**City of West Linn**  
**PRE-APPLICATION CONFERENCE MEETING**  
**Notes**  
**August 5, 2010**

**SUBJECT:** Two story addition at 5687 River Street, in Flood Management Area  
**ATTENDEES:** Applicants: Myrna and James Ochs, Harding DiCenzo (Builder)  
 Sally McLarty (Bolton N.A.) Staff: Peter Spir (Planning Department)

Pre-app2010-PA-10-24- FMA at 5687 River St

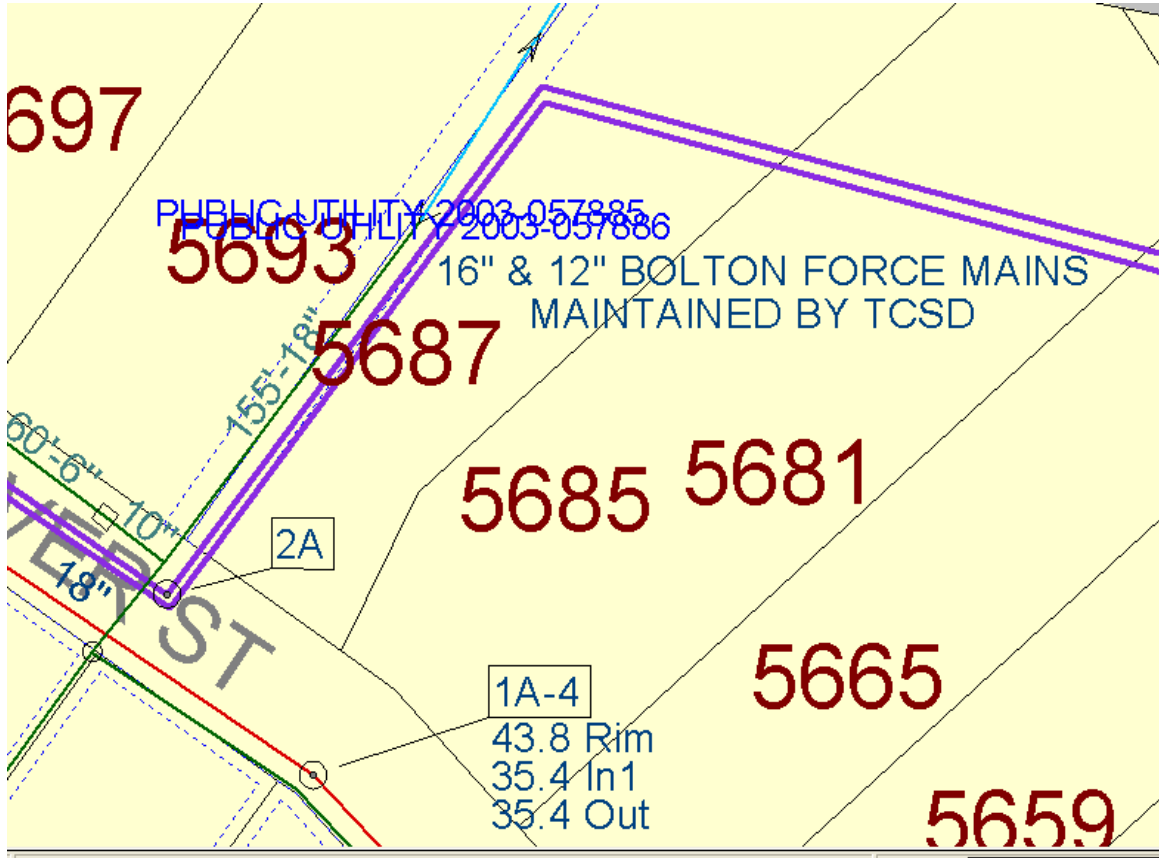
There is also the issue of the sanitary sewer lines and storm water lines on the northwest property line. The easement for the storm line is 20 feet wide centered on the common lot line to the west meaning that it extends ten feet onto the subject property. No part of the addition may encroach into the easement. The sanitary sewer forced main utility also has a ten foot wide easement from the west property line. The R-10 zone's 7.5 foot side yard setback is made redundant by the 10 foot wide storm and sewer easements. The applicant's site plan shows a side yard setback of over 10 feet. The proposed 21 foot front setback meets code requirement of a 20 foot setback.
